Groundwater and Wastewater Services File Imaging Project

# SOIL AND SITE REPORT FOR A GROUND ABSORPTION WASTEWATER SYSTEM

FEBRUARY 24, 1993

**LOCATION:** Mallard Creek Road I.D. # 029-171-27

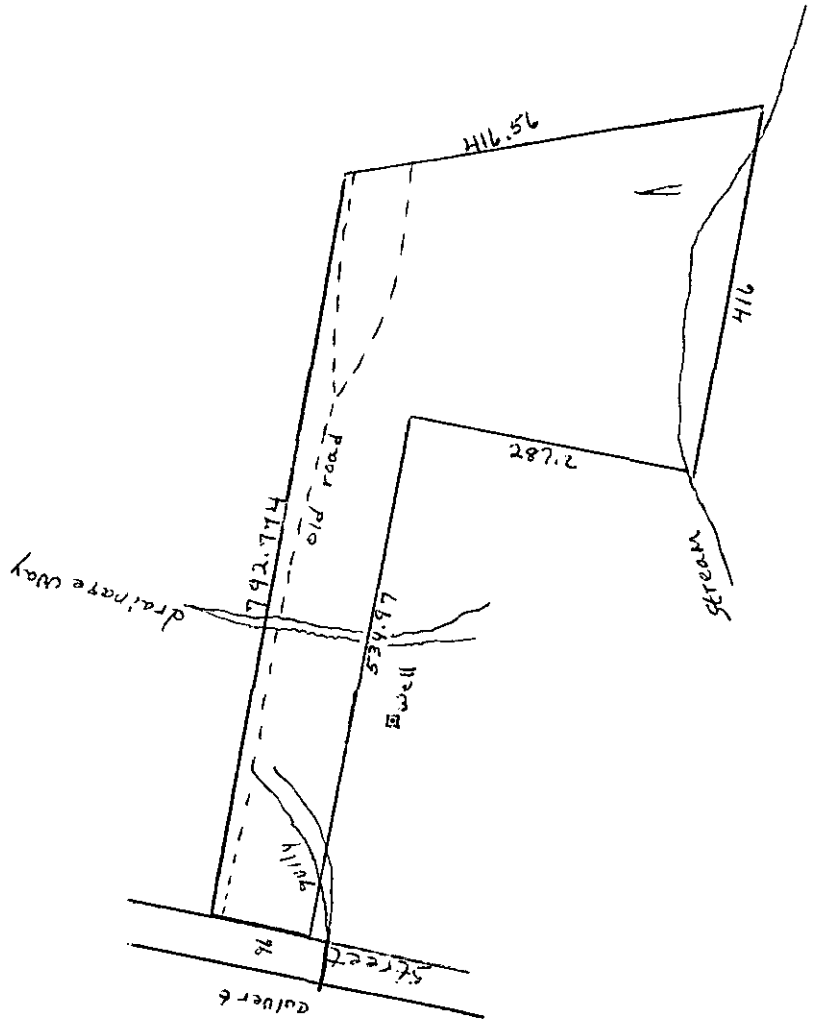
This site is unsuitable for the installation of a conventional ground absorption wastewater system due to:

1. Unsuitable Topography and Landscape Position — Section .1940
   Drainage features (gullies) and depressions
2. Unsuitable Soil Characteristics — Section .1941
   Expansive clay mineralogy
3. Unsuitable Soil Wetness — Section .1942
   Chromas of 2 or less from Munsell Color Book
4. Insufficient Soil Depth — Section .1943
   Soil depths of less than 36 inches
5. Insufficient Available Space — Section .1945
   Not enough area for an initial sewage system and a repair if needed.

The site is Unsuitable under Rule .1956 Modifications to Septic Tank Systems. Neither shallow trenches, large diameter pipe, nor porous block panel systems are options for this site. The saprolite is unsuitable by this rule. Drainage will not be sufficient to reclassify the site to Provisionally Suitable.

The site is Unsuitable under Rule .1957 Alternative Sewage Systems. Neither a low pressure pipe system, fill system, nor an aerobic treatment unit are options for this site.
